The cable harness in the A-pillar can cause electrical faults

Background

Fig. 1.

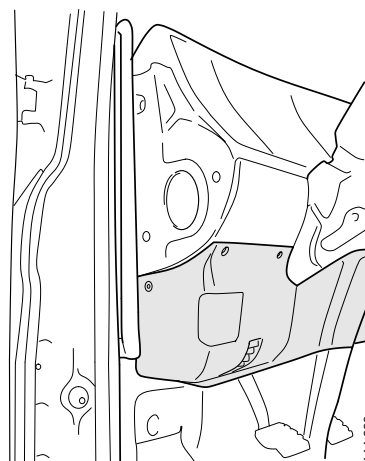
There is a risk of the cable harness being chafed at the exit from the A-pillar. This can occur on both the driver and passenger sides.

There is also a risk of the upper screw on the end of the protection cover, chafing into the cable harness and causing a short circuit.

1. Remove the protection cover mounted against the A-pillar. See fig. 1.
2. Loosen the connectors mounted between the A-pillar and the instrument panel.
3. Relocate the cable harness from the upper, to the lower hole in the A-pillar. Tape the holes' edges to protect the cable harness.
4. Cut approx. 20 cm of the slotted protection hose.
5. Slide the protection hose over the cable harness and tape together the protection hose.
6. Re-connect the connectors.
7. Re-fit the protection cover, using the shorter screws.

To protect the cable harness against damage, a protection hose is placed around the cable harness. At the same time, the screws for the protection cover are changed to a shorter length.

Fig. 2.

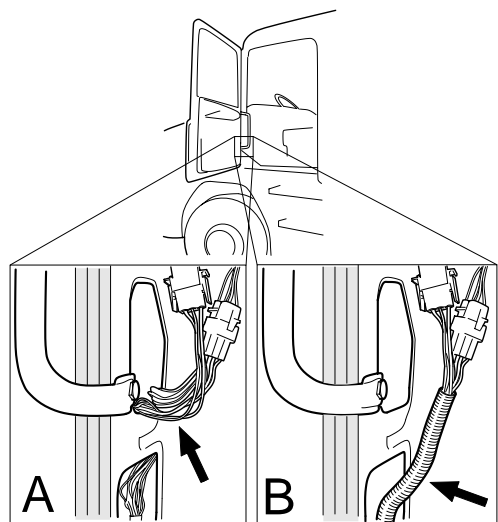
A: Old version.

B: New version.
